**SB-10051648-5392**

**Title:** Rear Exhaust Manifold Leak**Applies To:** MaxxForce® DT, 9 and 10 (2010 M.Y.)**DESCRIPTION**

Photo Showing the Revised Manifold

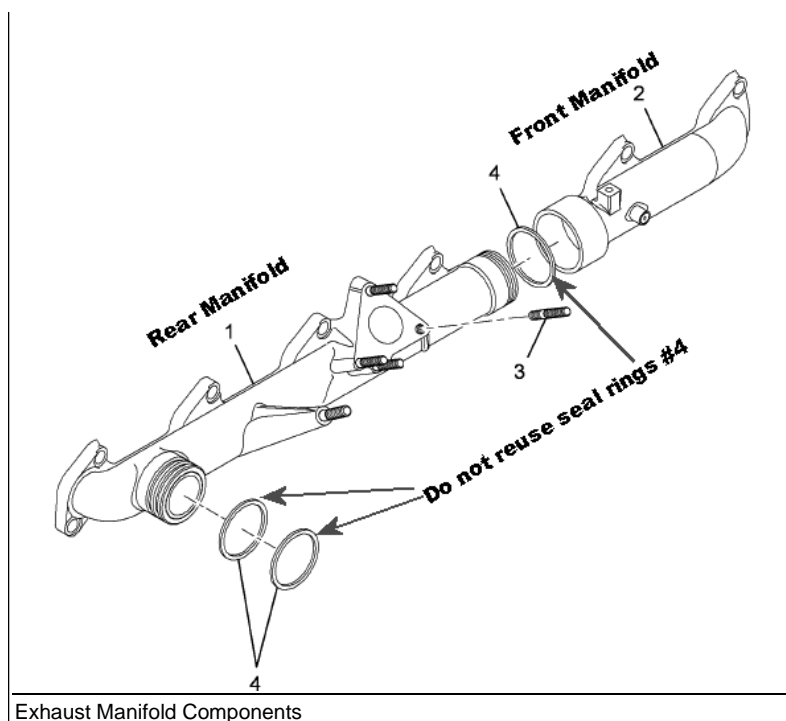
When truck is serviced for rear exhaust manifold leak, check for presence of a square shaped ear at rear of exhaust manifold. Current production exhaust manifolds have been modified to remove ear and existing inventories had these ears machined off.
